Thank you for your updating and could you please refer below is our ENERGY STAR Luminaires V2.2 Comments

主题: ENERGY STAR Luminaires Version 2.2 Draft Specification

The U.S. Environmental Protection Agency (EPA) is proposing to make minor adjustments reflected in the ENERGY STAR Luminaires Version 2.2 Draft Specification to support several new market developments and provide clarification on two requirements. Current certifications will not be affected by these changes.

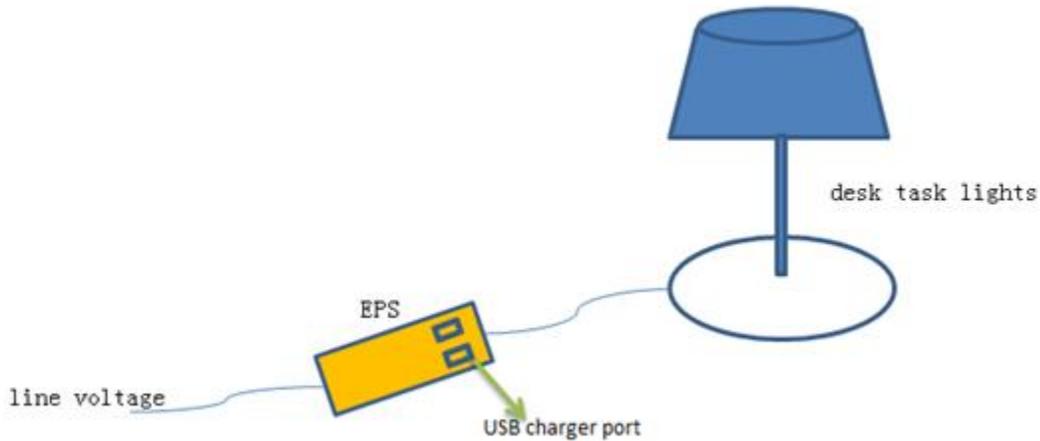
If portable desk task lights supplied by external power supplies(EPS),EPS output include 2 pcs of AC outlet or USB charger port, so according to ENERGY STAR Luminaires V2.2 section 11.5 , if required to comply EPS meet level VI or higher performance requirements.

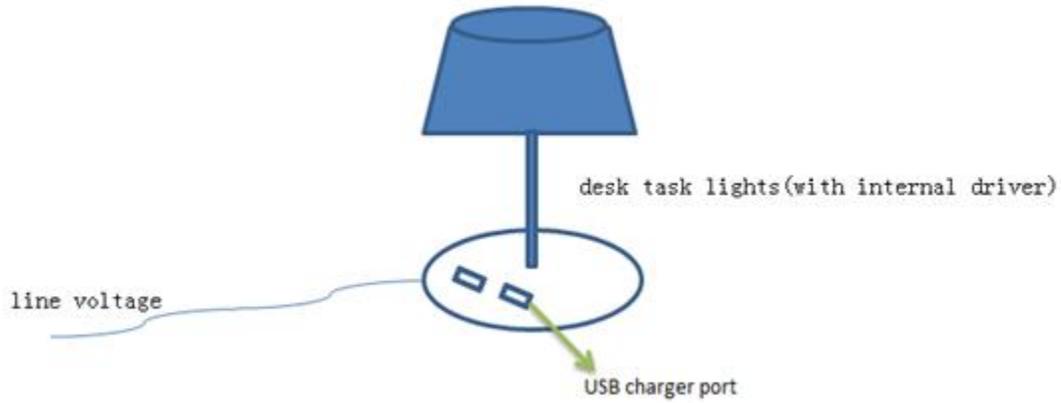
if portable desk task lights is supplied by one built-in LED Driver, and include 2pcs of AC outlet or USB charger port,

if required to comply with External power supplies (EPS) enabling USB charging functionality shall meet the level VI ?
